## 5<sup>th</sup> Meeting of Task Force Bumper Test Area Brussels, 30 Jan. 2014

### Position of European Car Manufacturers

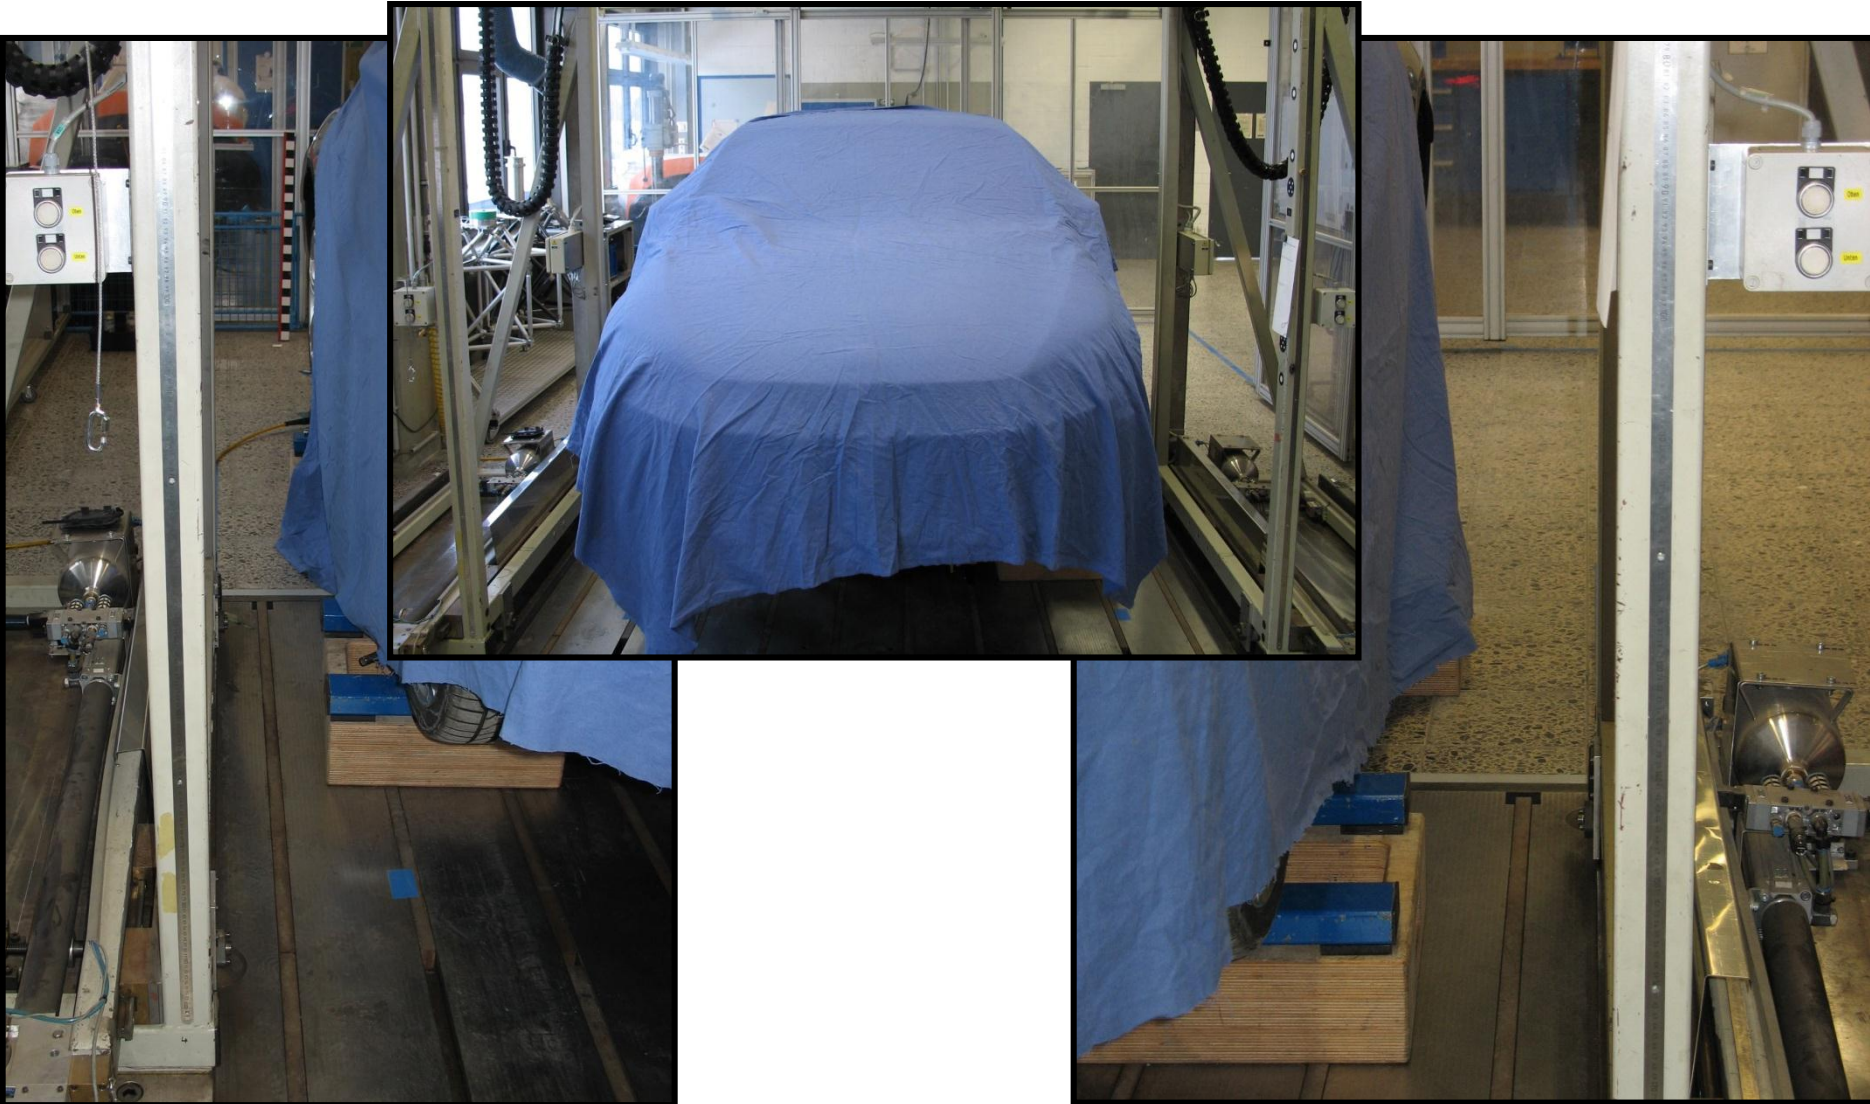
- As shown by Industry (and recognized by several experts in biomechanics), both legform impactors (EEVC LFI as well as FlexPLI) are in principle designed for 2D impacts
- Impactors have not been generally validated for testing against 3D surfaces. However, they may be acceptable (and are accepted) for today's test procedures. Outside of today's test areas the usability for testing is questionable
